ADDENDUM NO. 2

To the Drawings and Project Manual dated 16 June 2017

**TAS/ADA FIRE MARSHAL
DEFERRED MAINTENANCE PROJECTS
MIDWESTERN STATE
UNIVERSITY**

BOLIN SCIENCE HALL - FIRST FLOOR - AREA 1C
MECHANICAL DEMOLITION PLAN

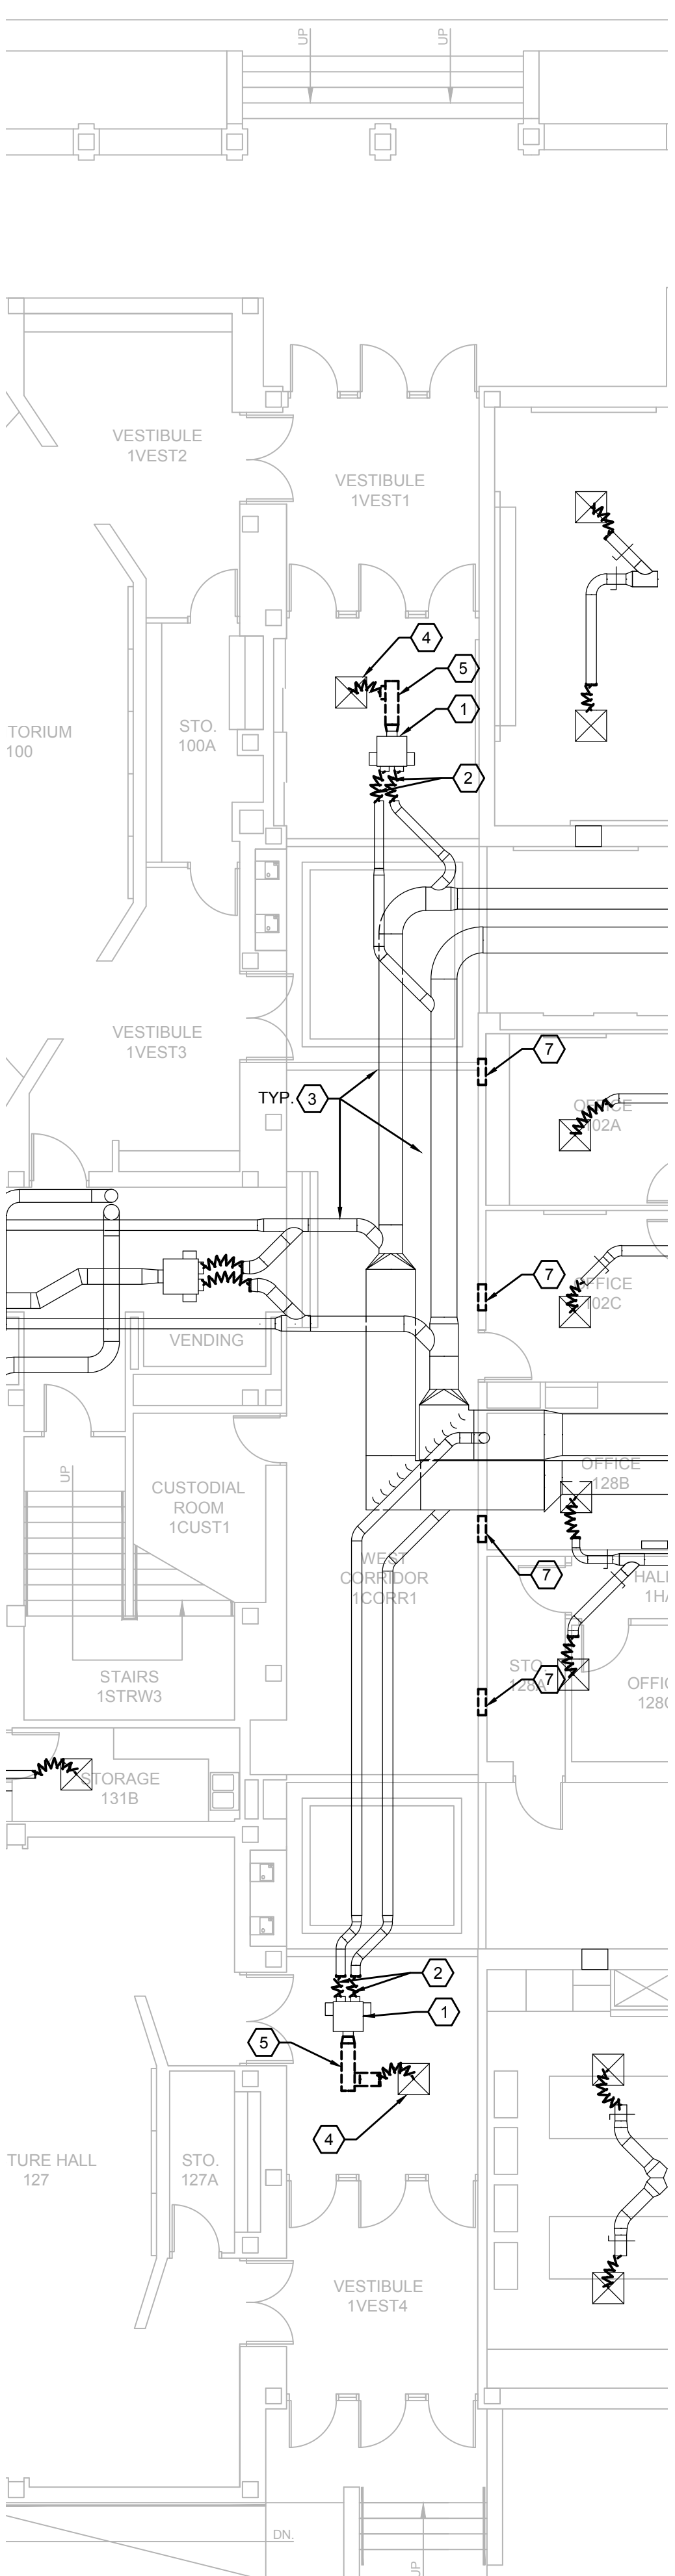
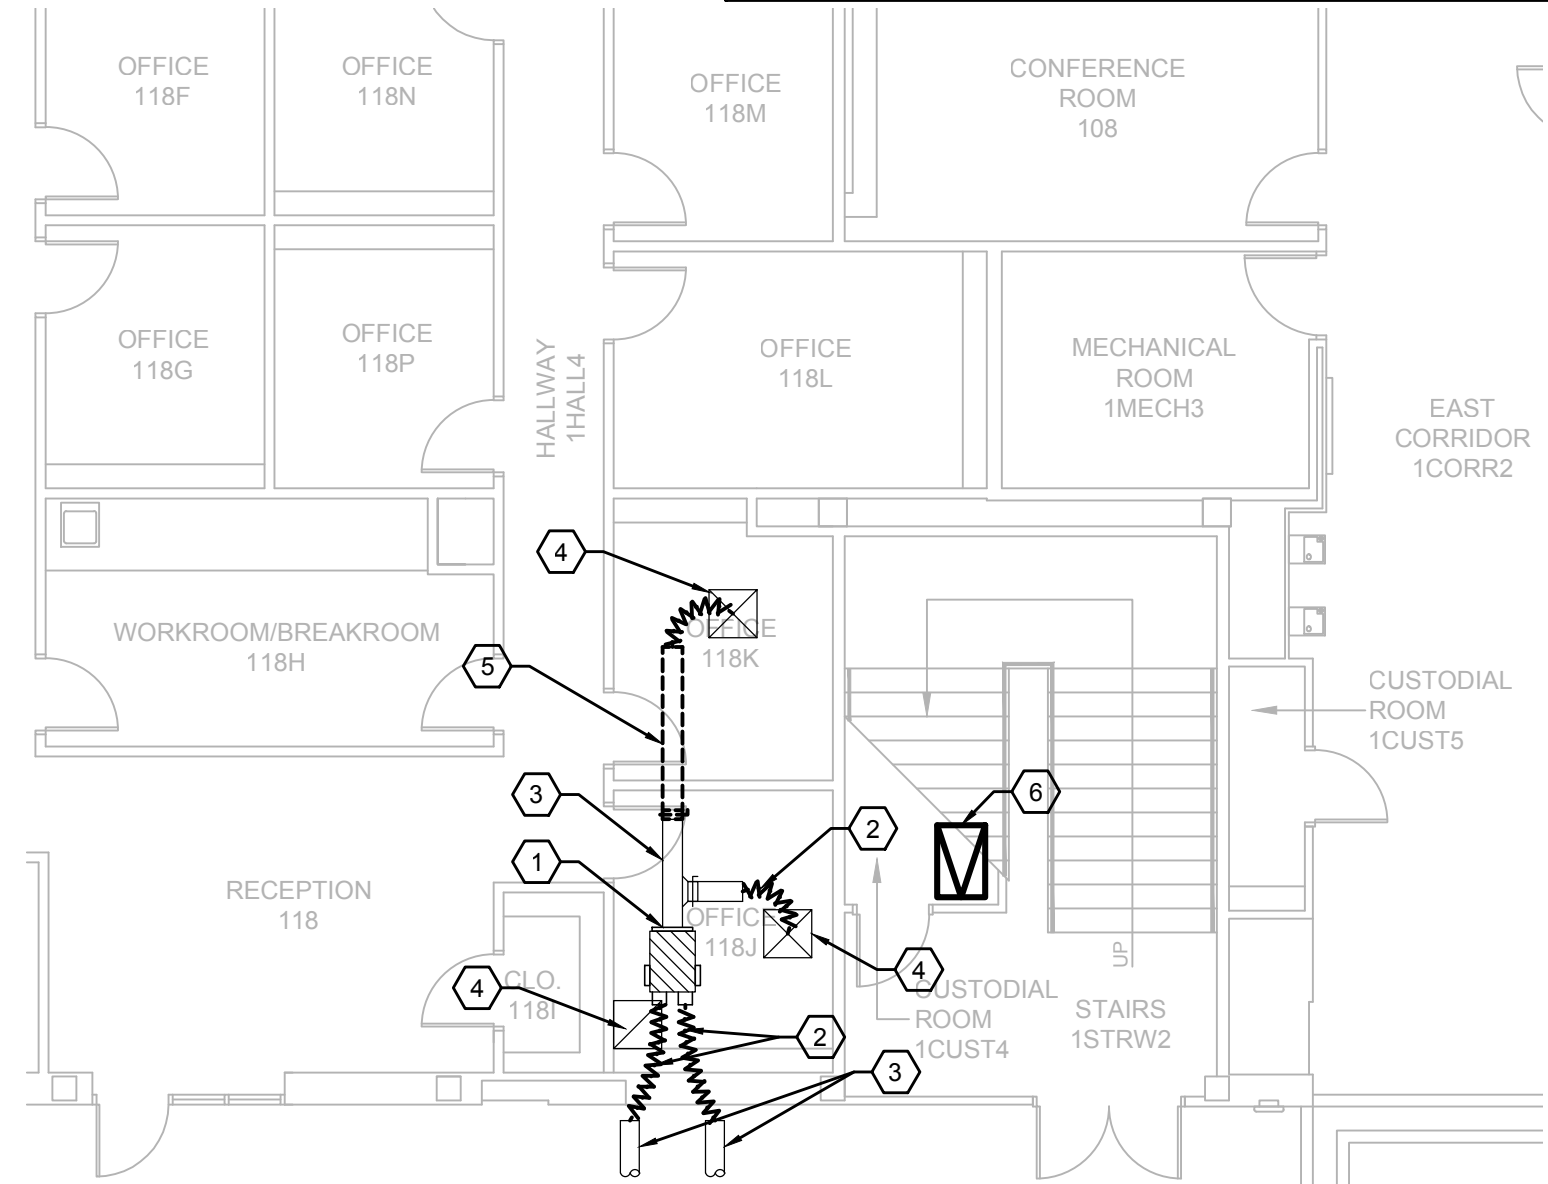
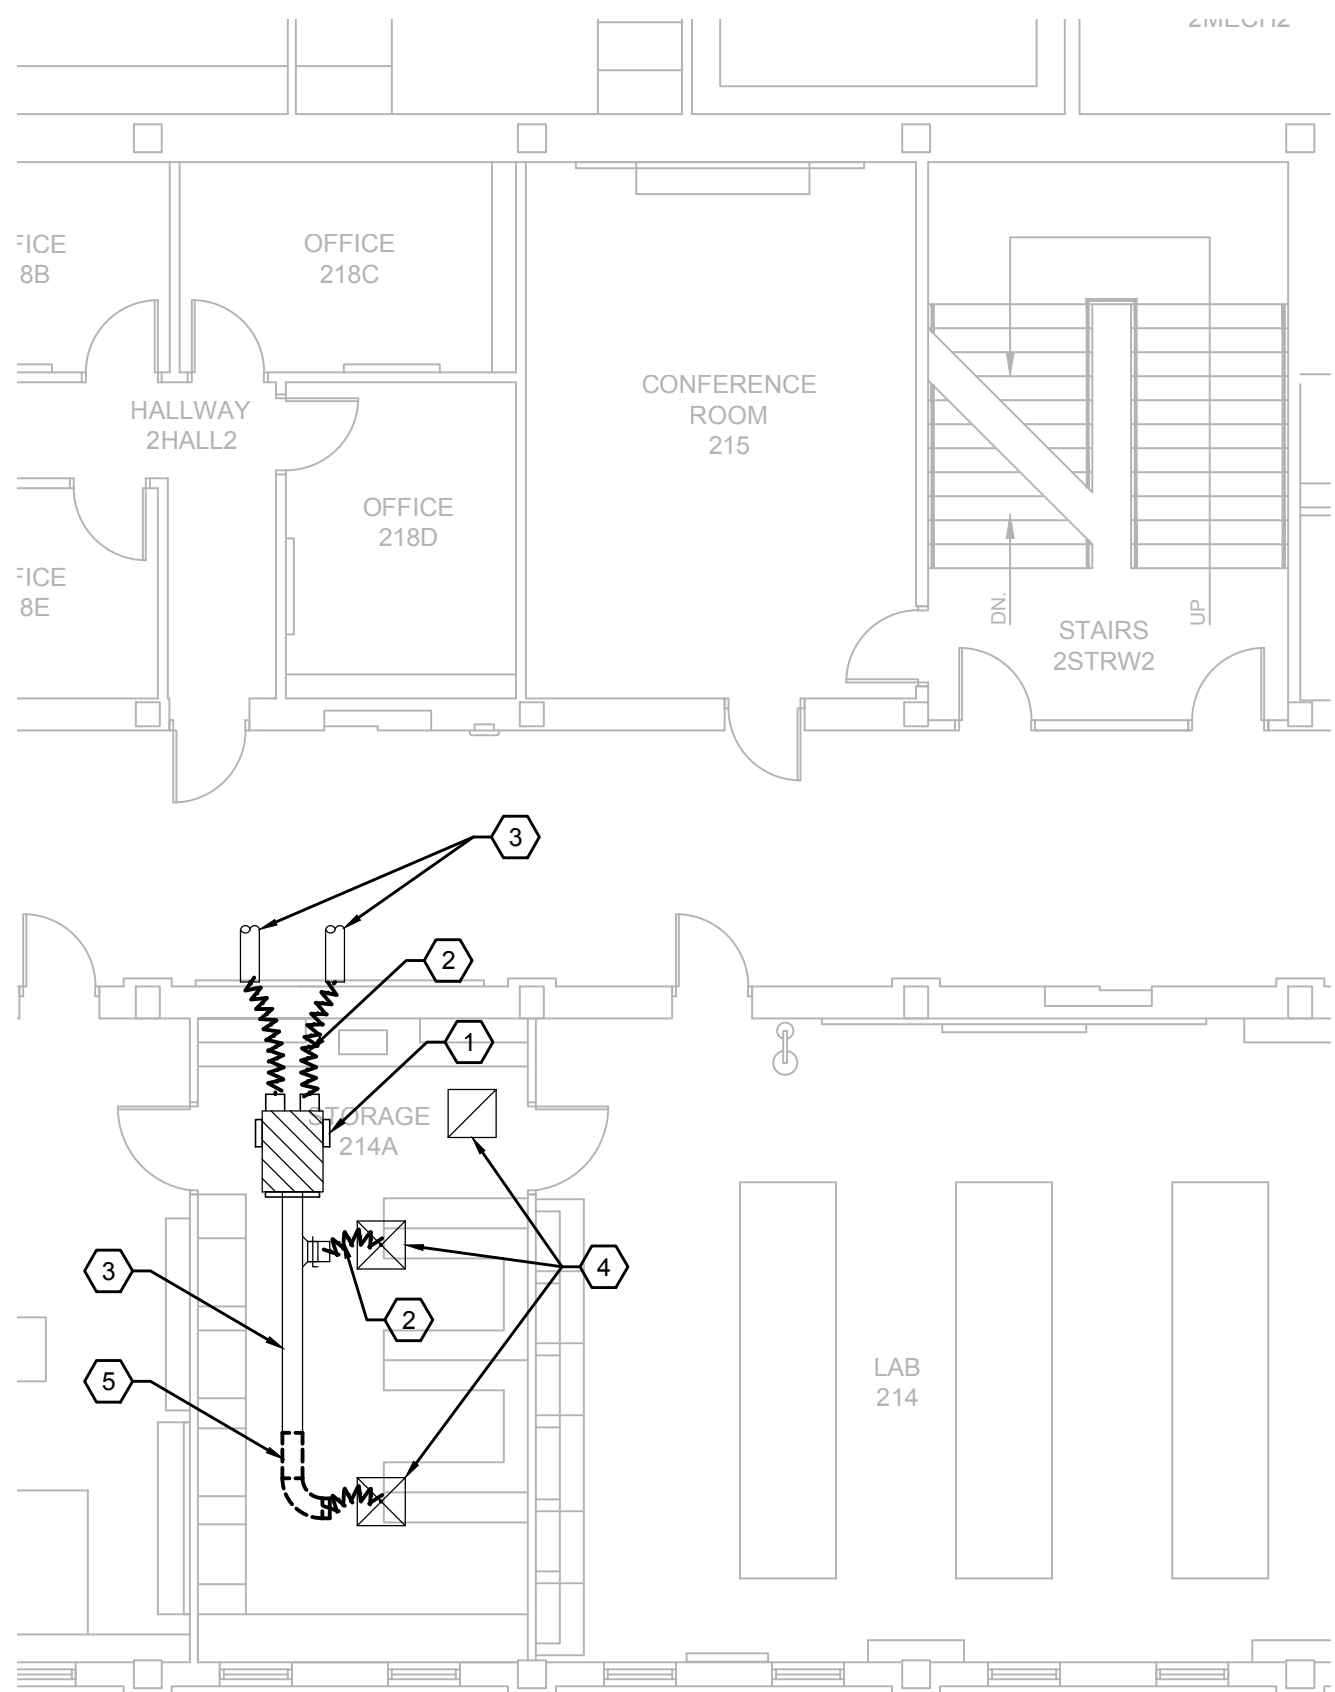
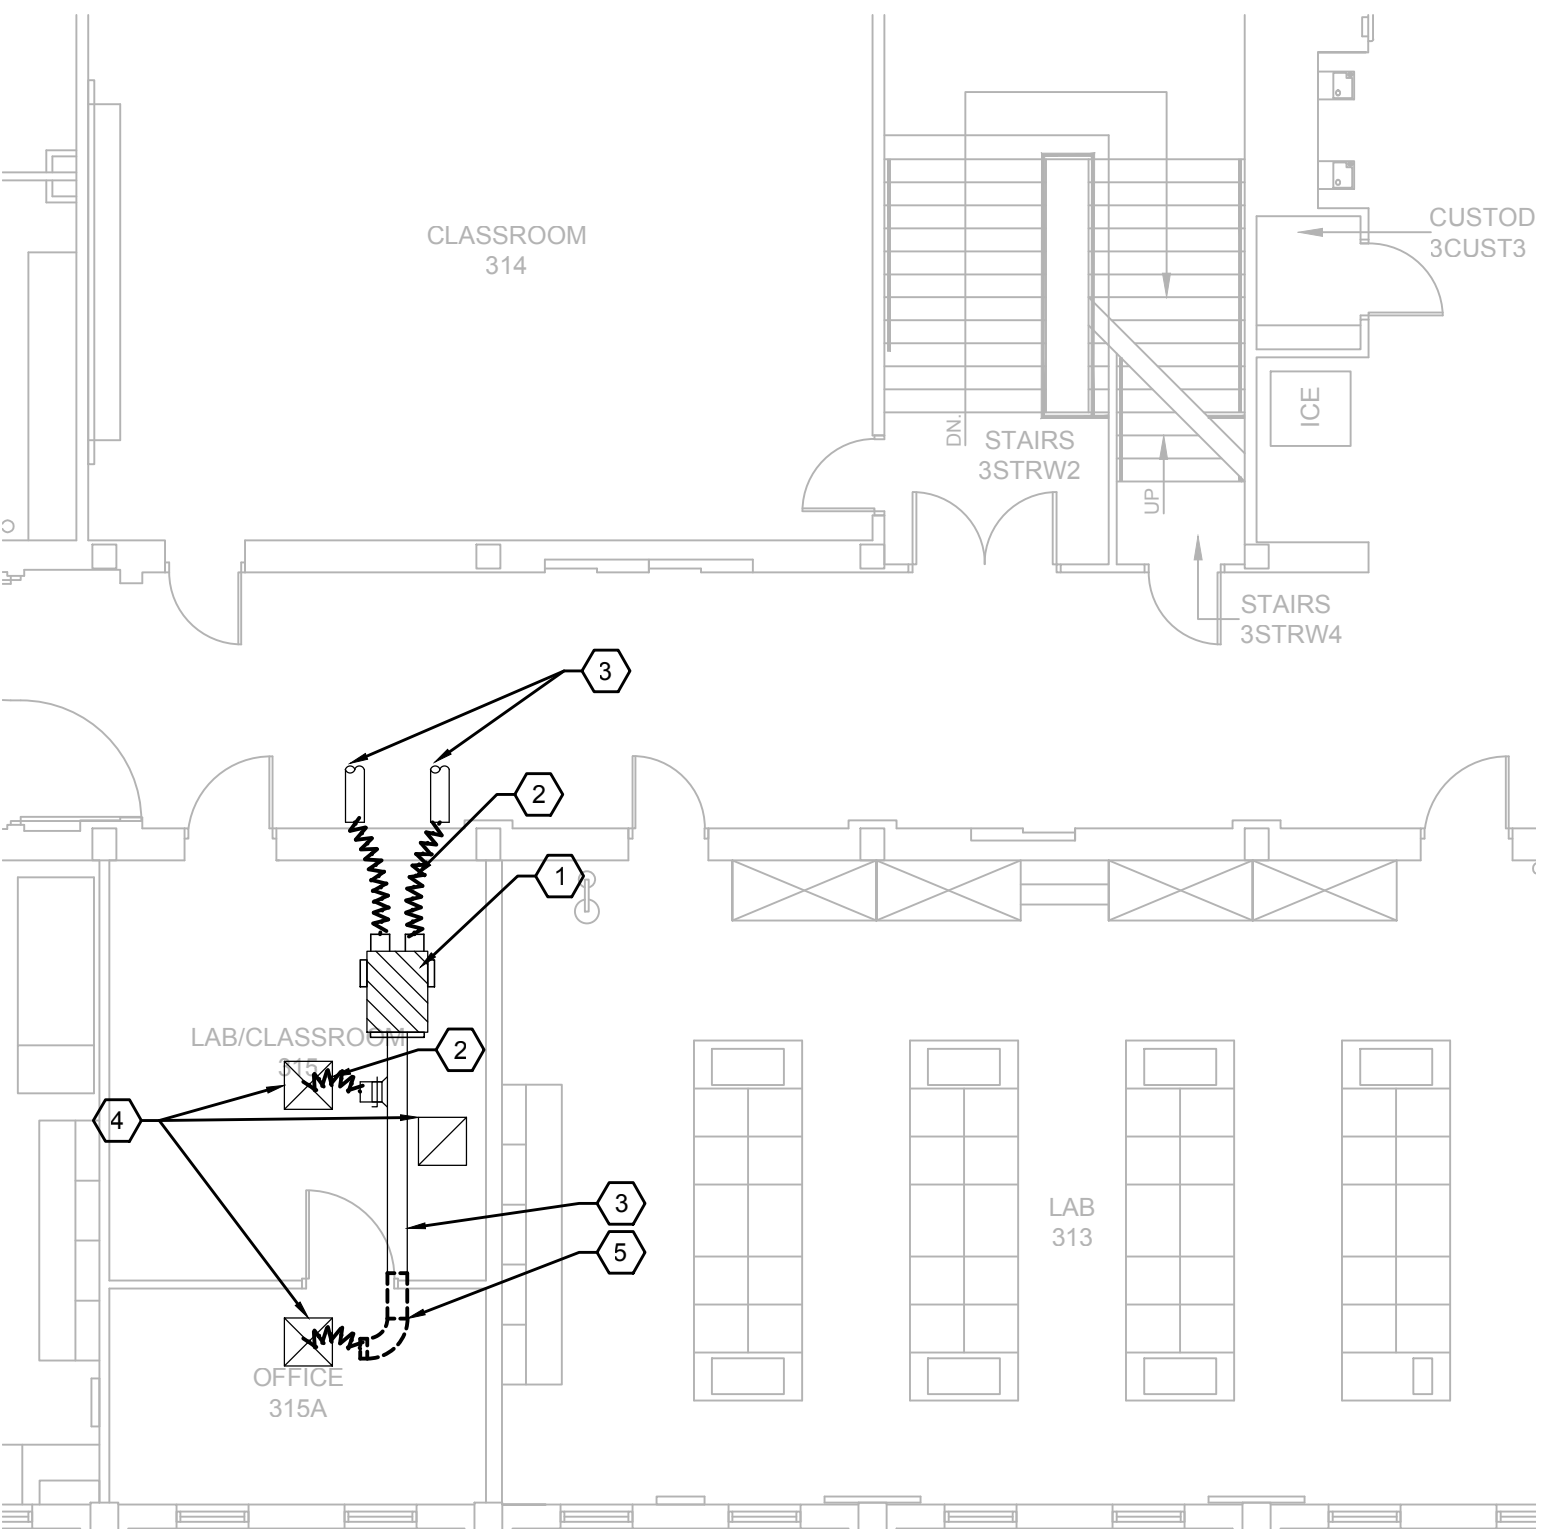
1. Sheet B-MD101– Revised Drawing as follows:
 - a. Rearrange sheet details to include HVAC demolition work in Area C1. It includes demolition of the supply and return ductwork serving the corridor as preparation for the inclusion of fire dampers.
2. Sheet B-M101– Revised Drawing as follows:
 - a. Rearrange sheet details to include HVAC work in Area C1. It includes new Key Notes #6 and #7 to call for the installation of fire dampers on the supply and return ductwork in the corridor.
